# RECOMMENDED SERVICE BULLETIN

## NO. RSB-42-066

#### **I.4 Subject**

Replacement of the check valve at the auxiliary tank (LH & RH) with a solenoid valve

**II.3 Material**

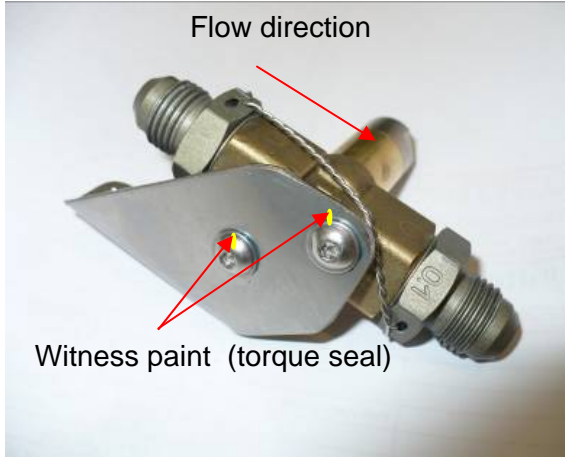
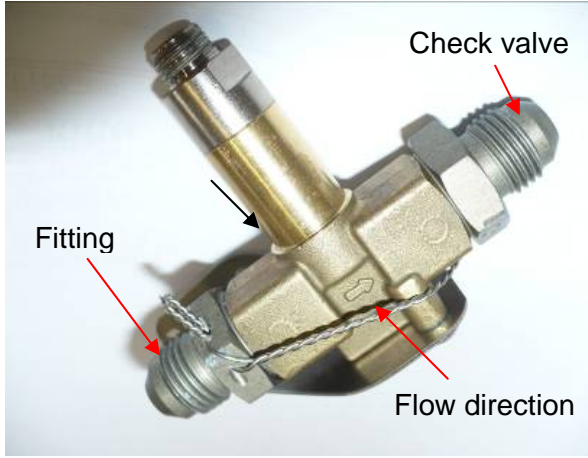
<p>Assemble all parts of the new solenoid valve in the following order:</p> <ul style="list-style-type: none"> <li>- Remove the solenoid from the valve by loosening the screw (metric wrench size: 16 mm).</li> <li>- Position the O-Ring (POR; 12.00x1.50; N7T40) in the fittings.</li> <li>- Apply Loctite Nr. 243 on both fitting threads.</li> <li>- Assemble the fitting which has a check valve at the RH side with a fastening torque of max. 18 Nm in acc. with AMM (Chapter 28-10-00).</li> </ul> <p><b>Note:</b></p> <ul style="list-style-type: none"> <li>- <b>The flow direction is signed on one side of the valve. Place the valve with the sign for the flow direction on top.</b></li> <li>- <b>Check if the arrow on the solenoid valve points to the correct side (where the check valve is installed). Compare your assembly with the following picture.</b></li> </ul> <p>7</p> <ul style="list-style-type: none"> <li>- Secure both fittings with a lock wire (Ø 0,25mm).</li> <li>- Fasten the bracket and the solenoid valve with two screws. Secure the screws with Loctite Nr. 243.</li> <li>- Mark the screw positions with witness paint (torque seal).</li> </ul> <p><b>Note: The bracket flange for mounting the assembly on the airplane is on the opposite side of the flow direction sign.</b></p>

<div style="display: flex; justify-content: space-around;"> <div data-bbox="288 1182 855 1637">  <p>Flow direction</p> <p>Witness paint (torque seal)</p> </div> <div data-bbox="868 1182 1458 1637">  <p>Check valve</p> <p>Fitting</p> <p>Flow direction</p> </div> </div>
<p>8</p>	<p>Assemble the prepared solenoid valve at the same position the check valve has been before (metric wrench size: 19 and 20mm).</p> <p><b>Caution:</b></p> <ul style="list-style-type: none"> <li>- <b>The flow direction, shown in the picture above, has to be in flight direction.</b></li> </ul>

18

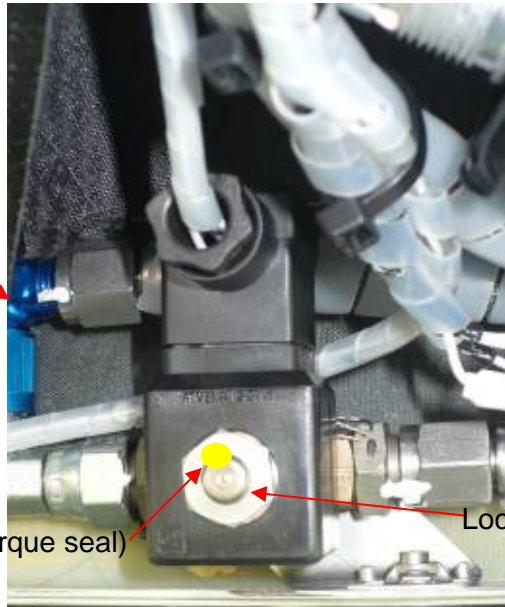
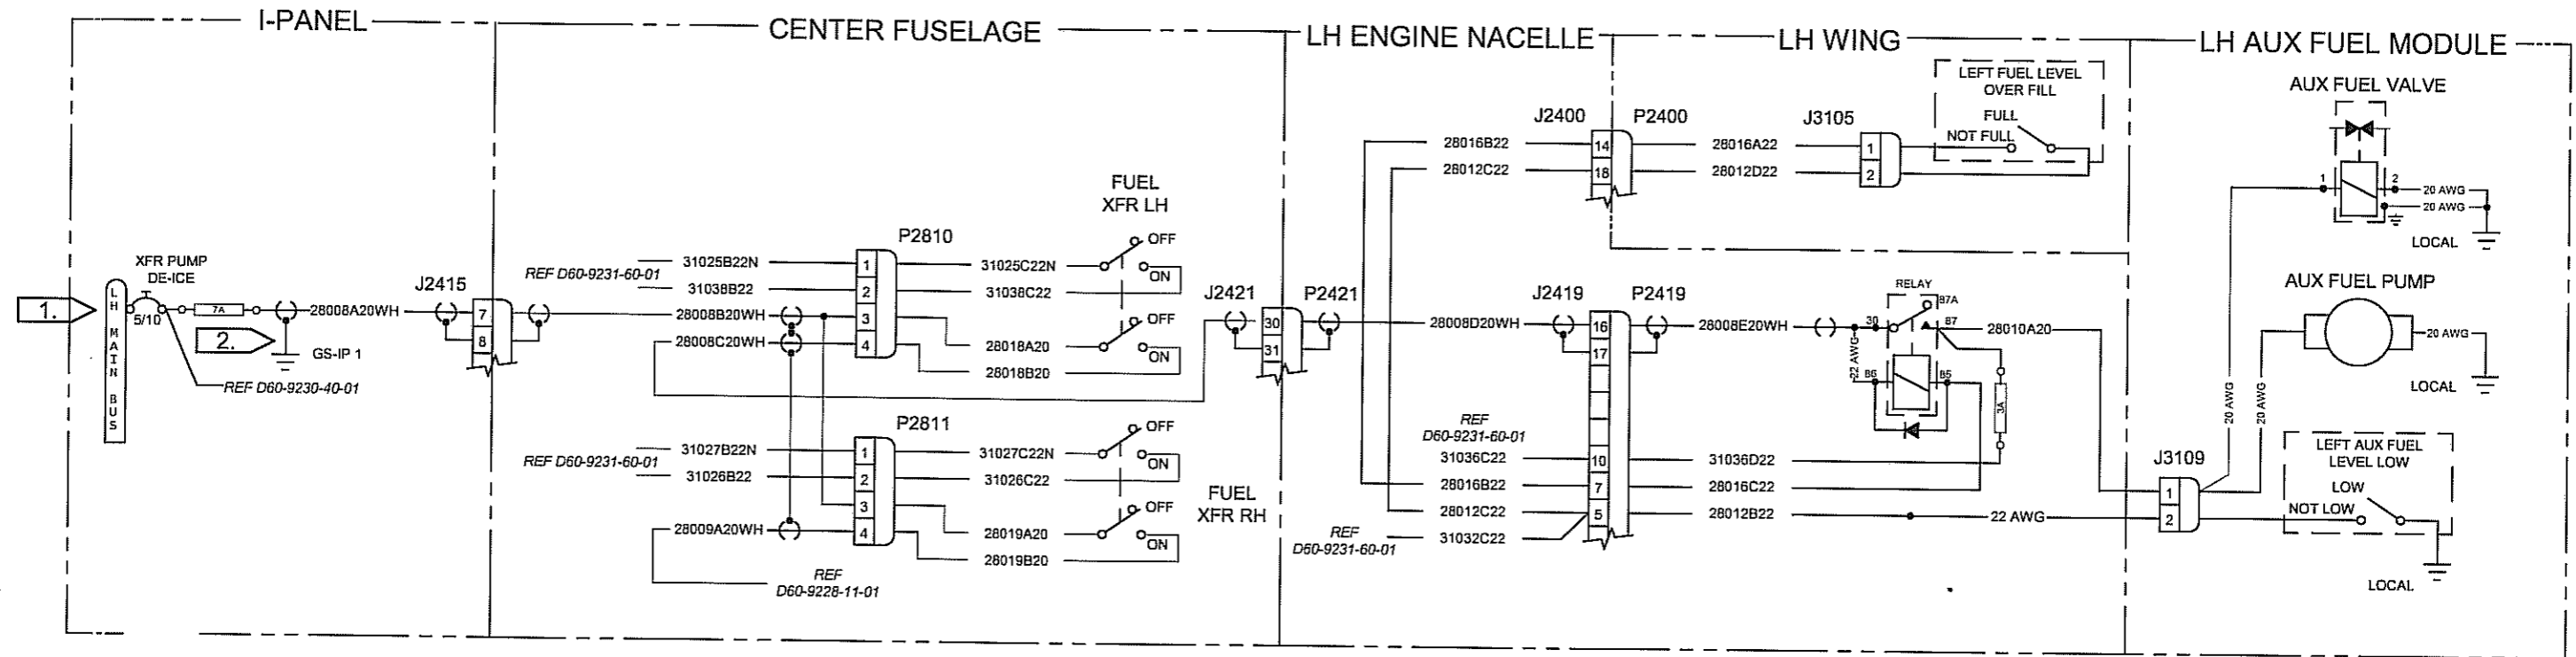
Apply Loctite 243 on the valve's thread and install the screw (metric wrench size: 16mm) and mark the screw with inspection lacquer.

**Note: Take care that the solenoid and the plug are in a vertical direction.**
